**ZONING AMENDMENT,
PLANNED UNIT DEVELOPMENT &
SUBDIVISION STAFF REPORT**

Date: December 6, 2012

<u>NAME</u>	Southeast Real Estate Acquisitions, LLC
<u>SUBDIVISION NAME</u>	Old Shell Road Elementary Subdivision
<u>LOCATION</u>	<p>Subdivision: 1706 Old Shell Road and 107 & 109 Gilbert Street (Northwest corner of Old Shell Road and Gilbert Street, extending 290 feet \pm North on Gilbert Street)</p> <p>Zoning and Planned Unit Development: 1706 Old Shell Road (Northwest corner of Old Shell Road and Gilbert Street)</p>
<u>CITY COUNCIL DISTRICT</u>	District 2
<u>PRESENT ZONING</u>	R-1, Single-Family Residential District
<u>PROPOSED ZONING</u>	R-3, Multiple-Family Residential District
<u>REASON FOR REZONING</u>	Changing conditions in a particular area make a change in the Ordinance necessary and desirable
<u>AREA OF PROPERTY</u>	3 Lots / 4.5 \pm Acres (Subdivision) 1 Lot / 4.1 + Acres (Zoning and PUD site)
<u>CONTEMPLATED USE</u>	<p>Subdivision approval to create 3 lots, Planned Unit Development Approval to allow multiple buildings on a single building site, and Rezoning from R-1, Single-Family Residential to R-3, Multiple-Family Residential District to allow a multi-family apartment co

SITE PLAN

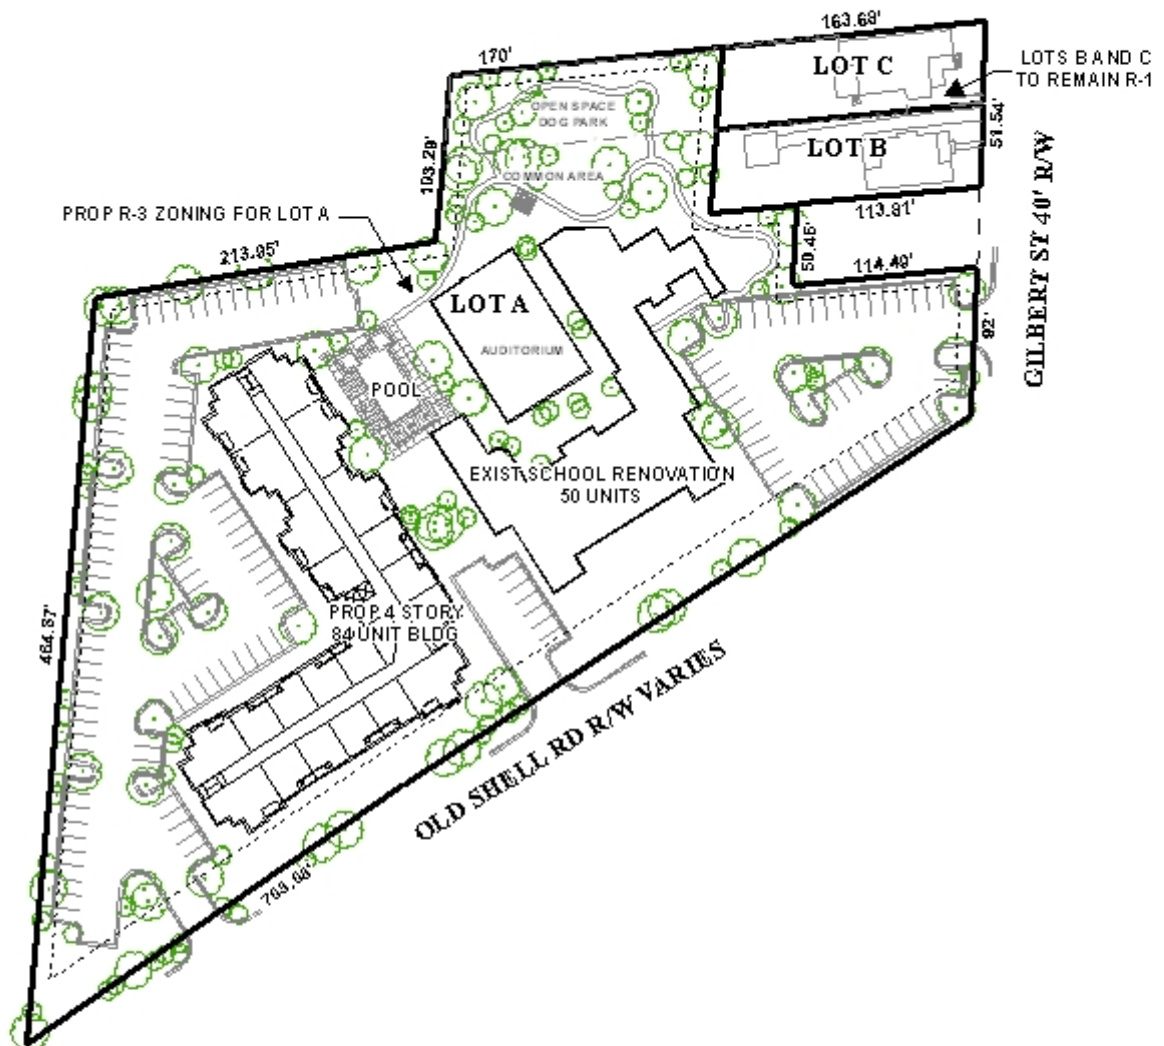
The site plan depicts new trees and landscape areas, and also indicates that some of the existing trees on site will be preserved. No calculations are provided, however, that allow staff to determine if the site will 1) have adequate overall and frontage landscape area, 2) that a minimum of 700 square feet of common area per dwelling unit will be provided (a multi-family residential PUD requirement), and 3) that the development will comply with the frontage, perimeter and parking area tree requirements.

The site plan also depicts a total of three new curb-cuts for the site. Two will be provided onto Old Shell Road, and one will be provided onto Gilbert Street. The proposed curb-cuts will replace four existing sub-standard curb-cuts on the site. The substandard nature of Gilbert Street makes the provision of a curb-cut for the multi-family development possibly questionable.

It should also be pointed out that no dumpsters are depicted on the PUD site plan. If dumpsters will be placed on the site, they must be depicted on the site plan if they will be outside. Additionally, the height of the new building should be indicated in feet, so that staff can determine if the proposed height will comply with the limitations for R-3 districts.

Finally, the plat indicates that the site is partially located within FEMA designated flood zones, however, preliminary research by staff indicates this to be incorrect. Also the plat has an error regarding the size in square feet of Lot A.

- 3) Revision of the site plan to provide 1. Total landscape area, 2. Frontage landscape area, 3. Frontage, perimeter and parking area tree calculations, and 4. Common area open space per dwelling unit calculations;

- 4) Revision of the site plan to eliminate access for the school site to Gilbert Street;
- 5) Revision of the site plan to depict any exterior dumpster storage locations;

- 6) Revision of the site plan to include a maximum building height for any new construction; and
- 7) Revision of the site plan to reflect dedication along Gilbert Street, and dedication of a corner radius at the Gilbert Street and Old Shell Road intersection.

- 1) Revision of the plat to depict dedication along Gilbert Street for Lot A to provide 25-feet from centerline;
- 2) Revision of the plat to depict dedication of a corner radius where Gilbert Street and Old Shell Road intersect;
- 3) Revision of the plat to correctly identify flood zones;
- 4) Revision of the plat to depict the 25-foot minimum building setback line on all lots, adjusted for any dedication; and
- 5) Revision of the plat to label each lot with its size in square feet, or the placement of the information on a table, reflecting any required dedication.
